NL-14-1745

Vogtle Electric Generating Plant – Unit 2
Completion of Required Action by NRC Order EA-12-051
Reliable Spent Fuel Pool Level Instrumentation

Enclosure 2

NRC Requests for Information

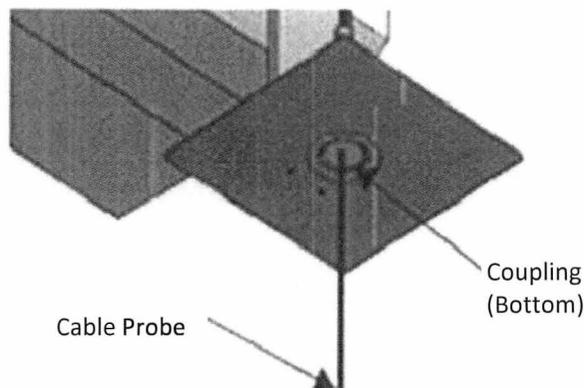
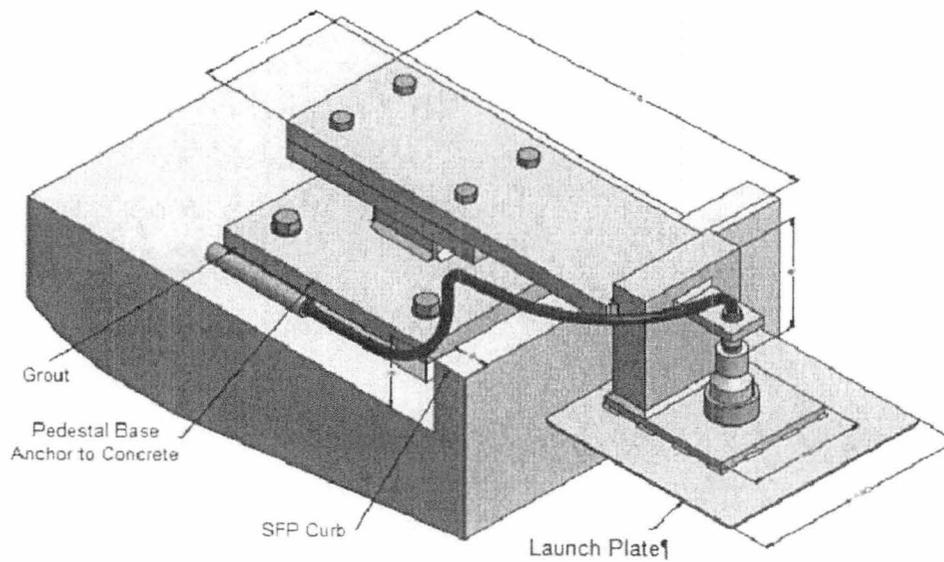
- a) A description of the manner in which the level sensor (and stilling well, if appropriate) will be attached to the refueling floor and/or other support structures for each planned point of attachment of the probe assembly. Indicate in a schematic the portions of the level sensor that will serve as points of attachment for mechanical/mounting or electrical connections.
- b) A description of the manner by which the mechanical connections will attach the level instrument to permanent SFP structures so as to support the level sensor assembly.

- a) The mounting bracket will be attached to the SFP concrete floor utilizing expansion-type concrete anchor bolts. The level sensor consists of a stranded stainless steel cable level probe that is threaded on the top end. The probe attaches (threads) into a coupling that is secured to the mounting bracket launch plate and extends down into the pool. The attachment to the signal cable is via a coaxial connection on the top side of the launch plate coupling.

The simplified drawing below shows a representation of the attachment of the probe and the sensor cable to the mounting bracket (launch plate), and mounting bracket attachment to the SFP structure.

- b) The level sensor (probe) is designed to be attached near its upper end to the mounting bracket, as described in the response to RAI 3a above. The mounting bracket will be attached to the SFP concrete floor utilizing expansion-type concrete anchor bolts. The mounting bracket to the SFP structure concrete floor anchorage is designed to meet the requirements of the Vogtle design and licensing basis for Seismic Category I components including seismic loads, static weight loads and hydrodynamic loads.

Figure 2

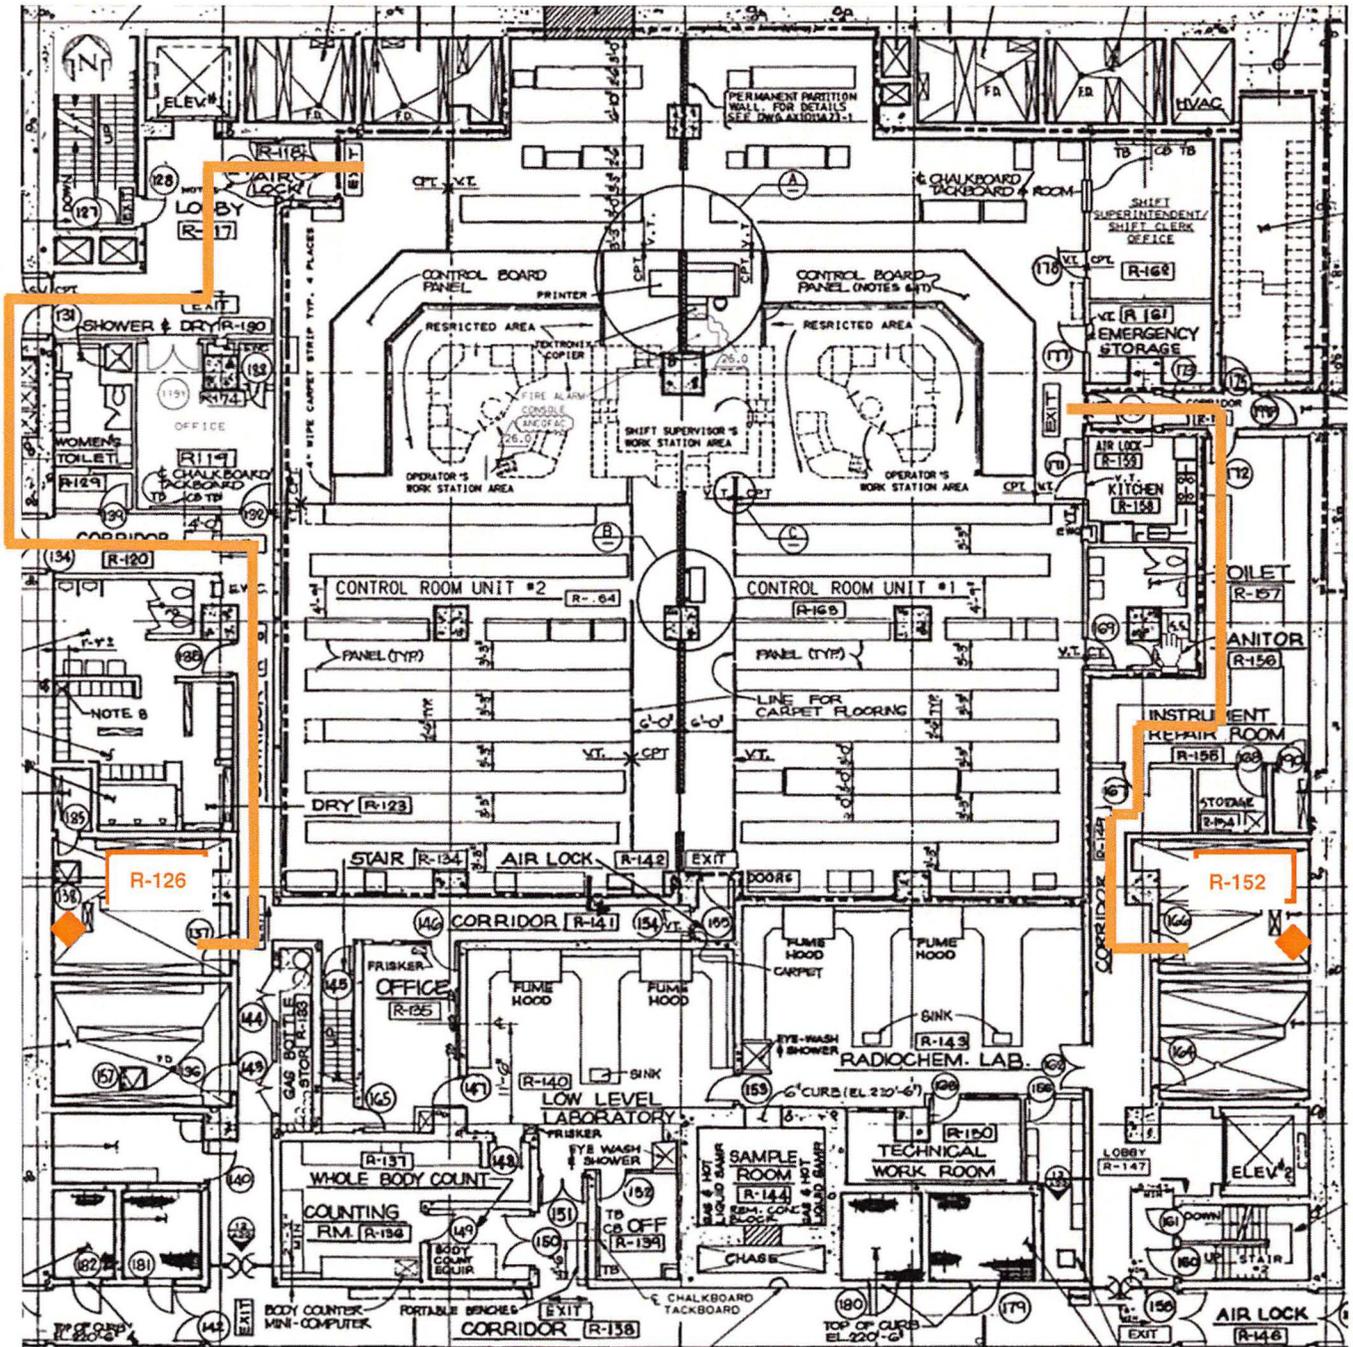
- a) The specific location for the primary and backup instrument channel displays.
- b) For any SFP level instrumentation displays located outside the main control room, please describe the evaluation used to validate that the display location can be accessed without unreasonable delay following a BDB event. Include the time available for personnel to access the display as credited in the evaluation, as well as the actual time (e.g., based on walk-throughs) that it will take for personnel to access the display. Additionally, please include a description of the radiological and environmental conditions on the paths personnel might take. Describe whether the display location remains habitable for radiological, heat and humidity, and other environmental conditions following a BDB event. Describe whether personnel are continuously stationed at the display or monitor the display periodically.

- a) See Figure 2 (Page E2-10) for SFPLIS equipment location sketches.
The proposed location of the display panels for VEGP Unit 2 is in room R-126 of the Control Building. The proposed location of the display panels for Vogtle Unit 1 is in room R-152 of the Control Building.
- b) The locations described in response to RAI 11(a) have been evaluated considering the accident conditions described in NEI 12-02 and NEI 12-06, using design inputs from Westinghouse, existing Station Blackout evaluations and NUMARC-8700, *Guidelines and Technical Bases for NUMARC Initiatives Addressing Station Blackout at Light Water Reactors*, dated November 20, 1987.
